APPEAL SUMMARY

Appeal ID: 21972	Project Address: 151 SW 1st Ave
Hearing Date: 10/9/19	Appellant Name: Luke Hendricks
Case No.: P-001	Appellant Phone: 5035420562
Appeal Type: Plumbing	Plans Examiner/Inspector: McKenzie James, Joe Blanco
Project Type: commercial	Stories: 5 Occupancy: B, M, S-1 Construction Type: III-A
Building/Business Name:	Fire Sprinklers: Yes - Fully Sprinklered
Appeal Involves: Reconsideration of appeal	LUR or Permit Application No.: 19-185198-CO
Plan Submitted Option: pdf [File 1] [File 2]	Proposed use: Office Building, Ground Floor Retail

APPEAL INFORMATION SHEET

4 PLAN, FLOOR - LEVEL 04 - PLUMBING
1/4" = 1'-0"

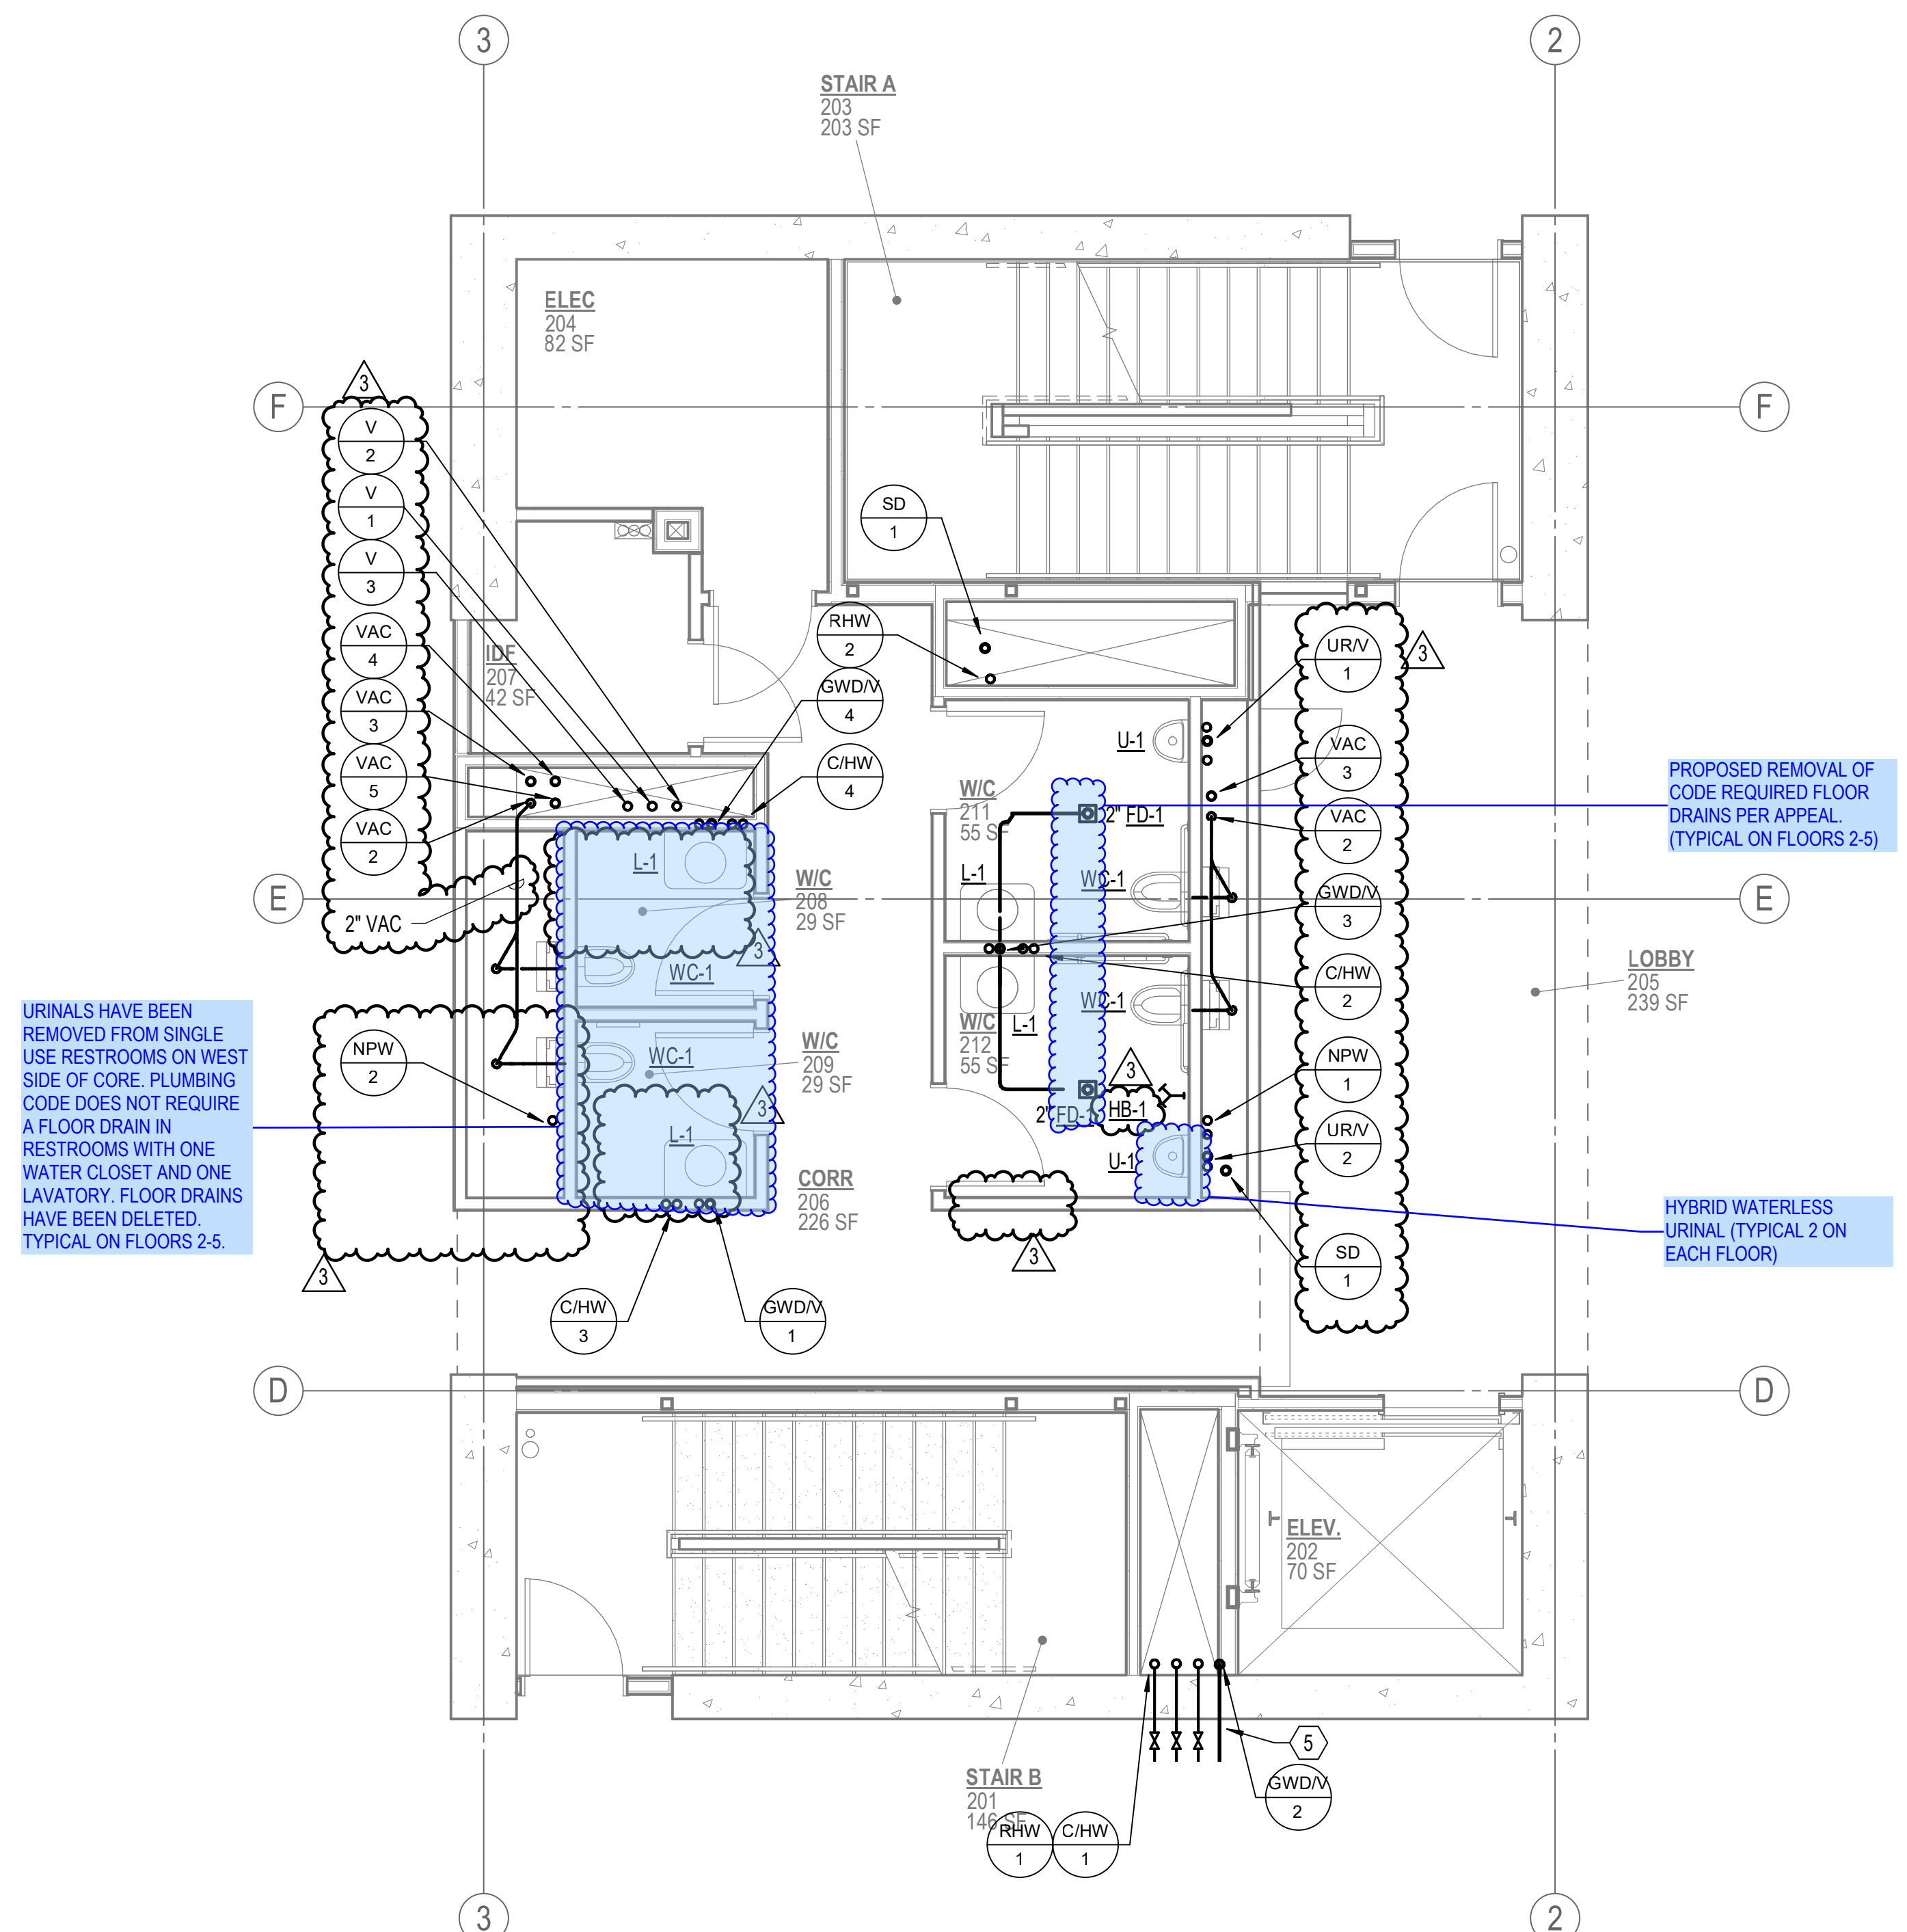
Proposed Design The building restroom core is comprised of four single occupant restrooms per floor on levels 2-5 and two single occupant restrooms on level 1. Each restroom is equipped with the following fixtures: low flow lavatory (0.35 GPM), a hybrid waterless urinal (1 gallon flushed every 72 hours via timer), and a low flow vacuum assisted water closet (0.12 GPF). A floor drain has been indicated in each restroom on the submitted drawings to meet the plumbing code.

Waterless urinals were initially provided in each single occupant restroom as a means to collect and divert as much urine as possible away from the composting system. The quantity of urinals initially proposed is above the building code minimum fixture quantity requirements based on occupancy load calculations. Additional urinals are beneficial to the operation of the composting system as it helps to reduce liquid in the system but is not a mandatory requirement. As a savings to the project, urinals will be removed from two of the restrooms on each floor. Removal of the urinals will also remove the plumbing code requirement to provide floor drains in those restrooms. This change will be implemented via a forthcoming addendum to the submitted drawings.

The proposed design is to remove the floor drains from the remaining single occupancy restrooms on levels 2-5 which is an exception to the plumbing code because they will be equipped with a lavatory, water closet, and waterless urinal. Floor drains will be provided in ground floor level 1 restrooms and mechanical room to provide low point drainage for the building.

Reason for alternative Under the current code, a single occupant, single flush fixture restroom does not require a floor drain. Waterless urinals are not technically a flush fixture. An exception to the code should be considered to not include the waterless urinal in the “two or more water closets or a combination of one water closet and one urinal” that triggers the requirement for a floor drain.

Due to the aggressive goals for water savings in this project, the proposed water closets and waterless urinals have a much lower flowrate than typical restroom flush fixtures. The proposed hybrid waterless urinals flush only 1 gallon every 3 days and proposed water closets flush only 0.12 Gallon per flush (GPF). This is over a 90 percent water reduction compared to low flow flush urinals (0.125-0.5 GPF) and water closets (1.28-1.6 GPF). The proposed plumbing fixtures only require a 1/2-inch water supply connection compared to 1-inch to 1-1/4-inch for standard flush fixtures. Additionally, the water connections are located within the fixtures where any leak or malfunction would send water into the fixture. A typical flush valve is exposed above the fixture with the potential to leak a higher quantity of water onto the floor. The code required floor drain is intended for emergency use due to the presence of multiple flush valves in commercial restrooms that are intended for more than a single user. The proposed fixtures have flow rates and water connection sizes similar to those found in a dwelling unit and therefore do not pose a high risk of flooding compared to a restroom with multiple exposed flush valves. In the event of a fixture overflow, the flow rates of fixtures are so low, that the volume of water would be minimal in comparison to a standard flush valve. Removal of the floor drain is proposed due to the lowered risk of flooding by the proposed fixtures.

A typical use for the floor drains in larger commercial restrooms is for cleaning or hosing down the floors. The proposed single use restrooms will be cleaned using a mop and bucket therefore the floor drain will not be needed for cleaning or sanitary purposes. For this reason, removal of the floor drain will provide equivalent health to the code required floor drain.

Trap primers are required for floor drains and utilize water to maintain the trap seal. An additional water savings can be achieved by removal of the code required floor drains and trap primers because water will not be required to maintain the seal in the floor drain traps. An energy savings can also be achieved by removal of the electronic trap priming manifolds which require an electrical connection for operation.

1. Omission of floor drains: **Denied. Proposal does not provide equivalent sanitary facilities.**
2. Use of the provisions of 2017 OPSC Appendix K for potable rainwater catchment system in a

POTABLE SUPPLY -
FLOW SCHEMATIC

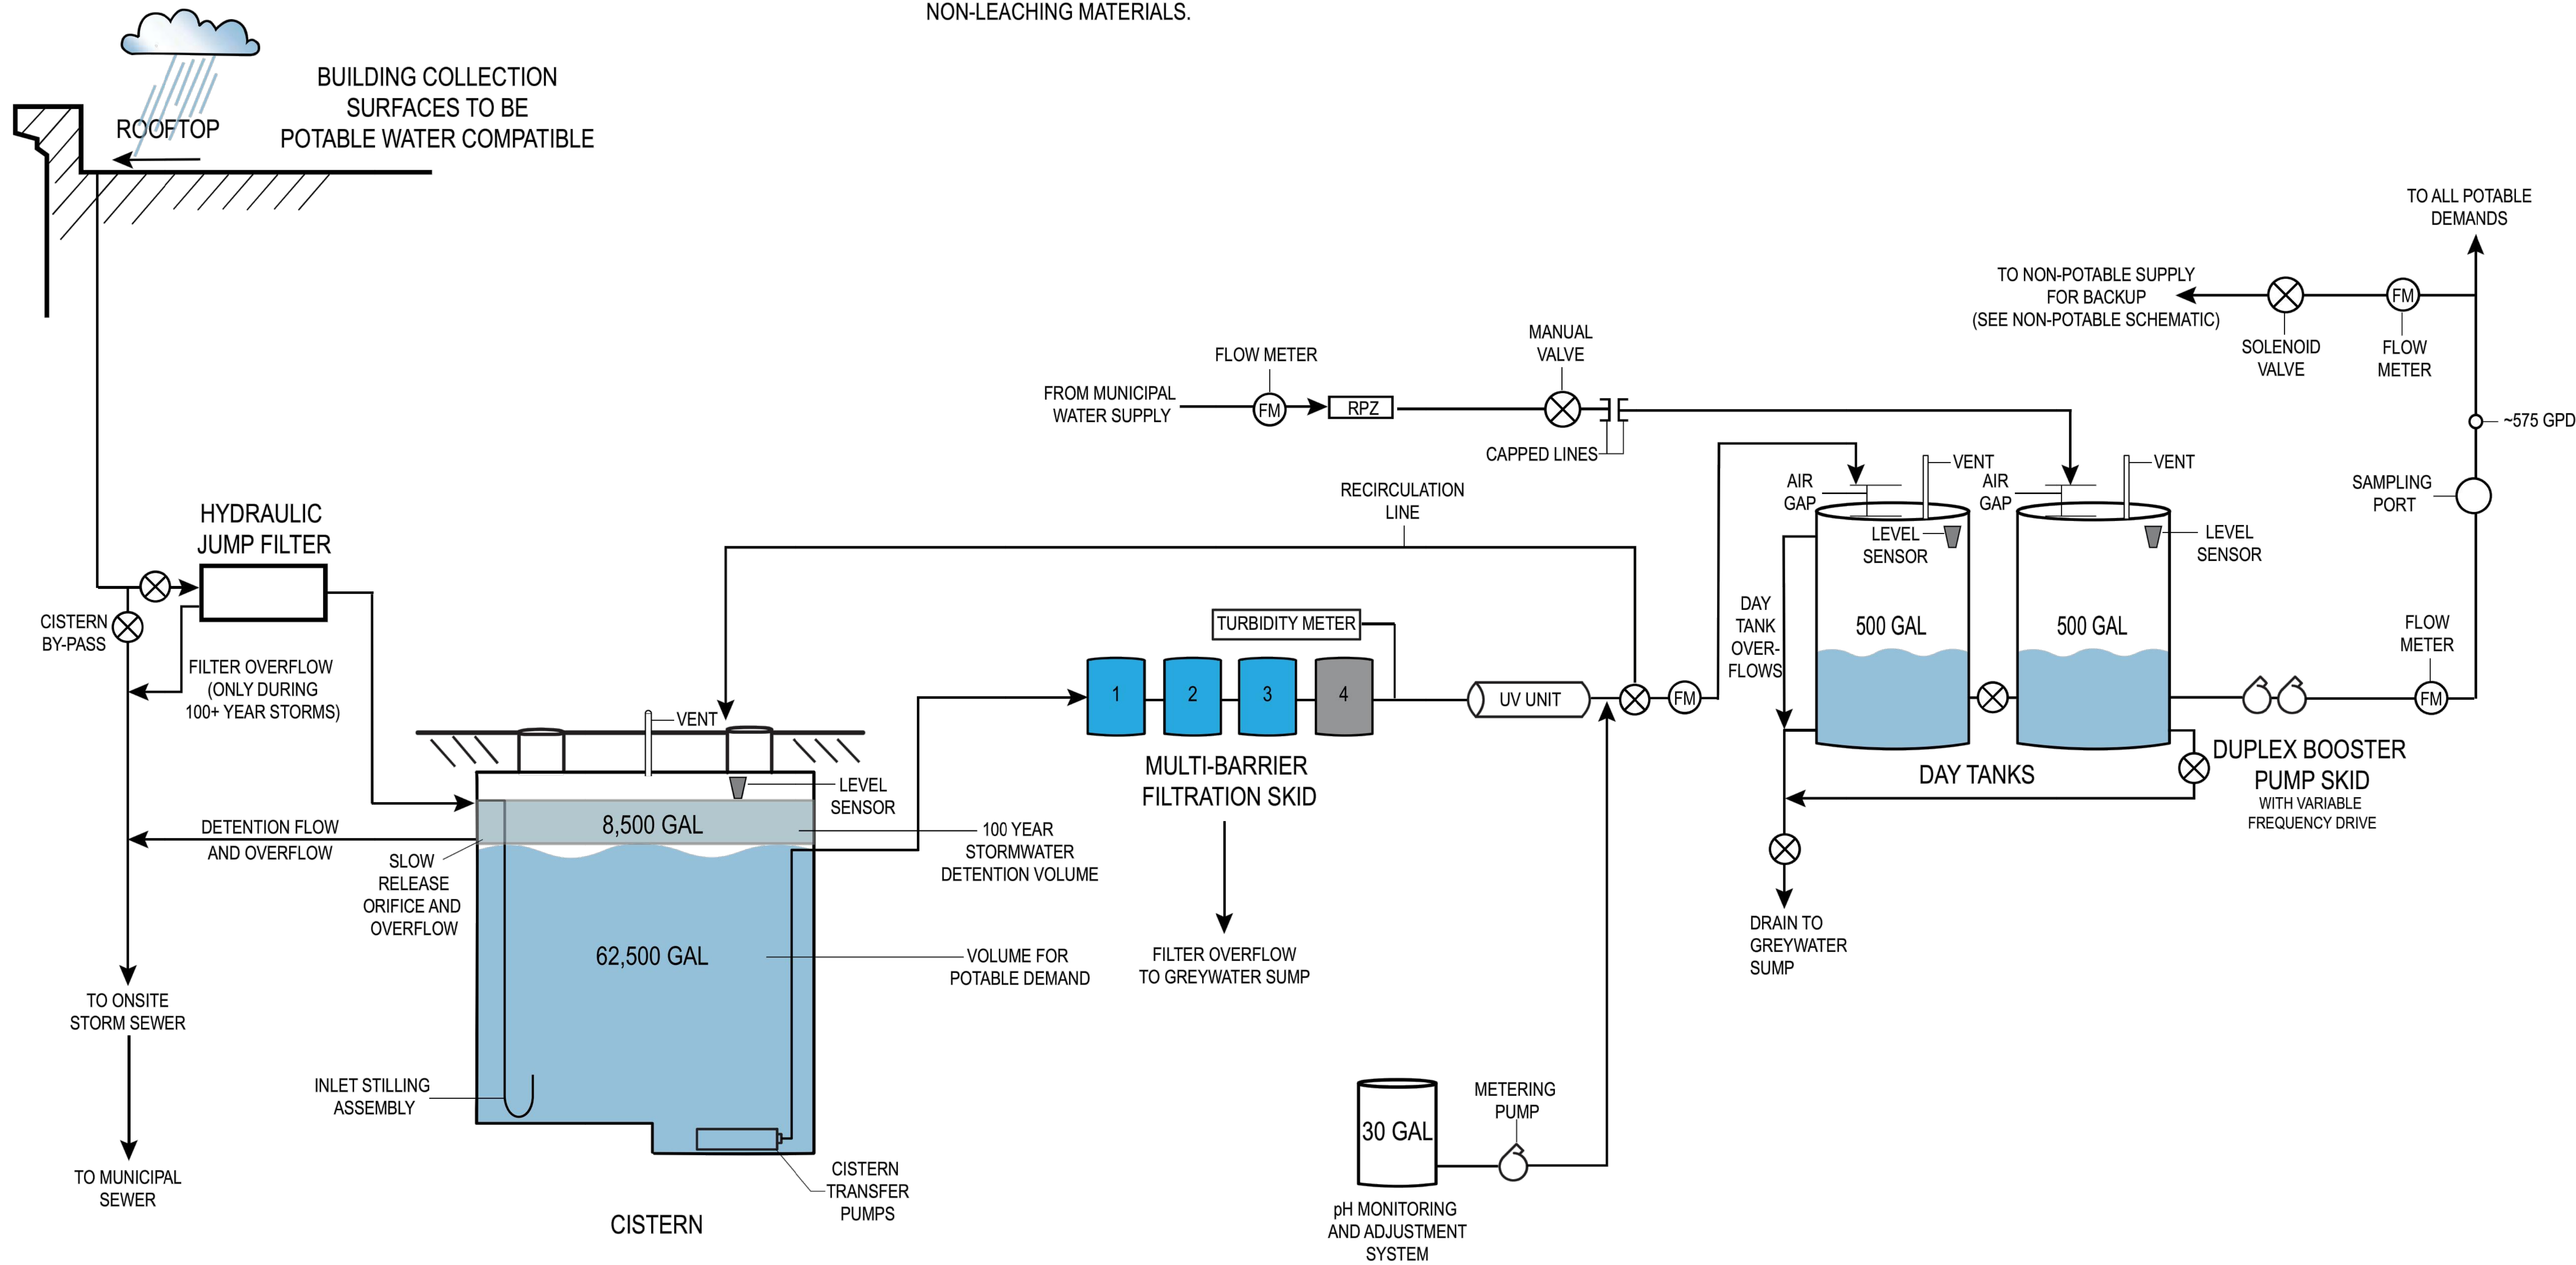
Proposed Design The proposed design will follow the provisions of Appendix K for potable rainwater catchment system in a commercial office building.

Reason for alternative In the absence of a commercial code for potable rainwater catchment systems, the alternate is required to provide equivalent health and life safety in a commercial office building as the code requires for a single-family dwelling.

commercial office building: Granted as proposed.
